Review of Carbon TerraVault (CTV) Responses to EPA's Questions about the AoR Delineation Modeling Approach for the A1-A2 Class VI Project

In January 2022, EPA provided questions (*blue, italic text*) to CTV about the AoR modeling and modeling-relevant site characterization information in the permit application narrative and in the PISC and Site Closure Plan (Attachment E) submitted with CTV's Class VI permit application (dated August 30, 2021) for the proposed Carbon TerraVault (CTV)-Elk Hills Class VI geologic sequestration (GS) project. CTV provided an updated Area of Review and Corrective Action Plan and PISC and Site Closure Plan to EPA on March 31, 2022. EPA's evaluation of how the updated plans address its questions is presented in **red** below. Requests for revisions and additional information are presented in **red, bold, and italic** below. Previous responses that require no further information are not included in this enclosure.

Figure 4: Schematic section of the storage site with inputs to critical pressure calculation. Values for the USDW are based on the 326-7R well. The injection depth is based on the 357-7R injector. Using data from wells 357-7R injector and 326-7R the critical pressure is 3,400 PSI.

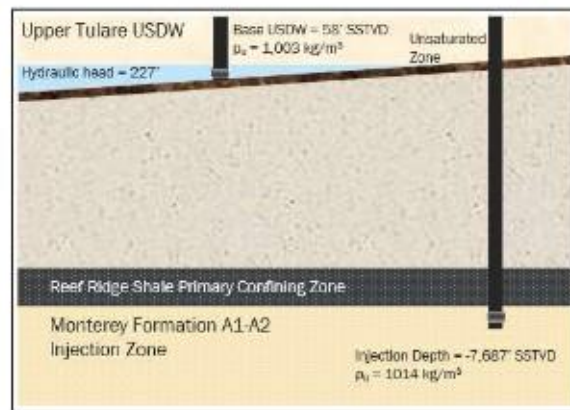
CTV submitted their critical pressure calculation to the GSDT in a file titled “Critical—Pressure—Calculation.PDF.” Using the inputs from Figure 4 and equation listed on pg. 3 of the Critical—Pressure—Calculation PDF, the critical pressure was calculated to be 3,400 psi. The final pressure of the Monterey Formation A1-A2 reservoir will be at or below the initial reservoir pressure of 4,000 psi, ensuring that post-injection conditions replicate those of initial conditions to the extent possible. Therefore, the AoR is based on the extent of the modeled CO₂ plume.
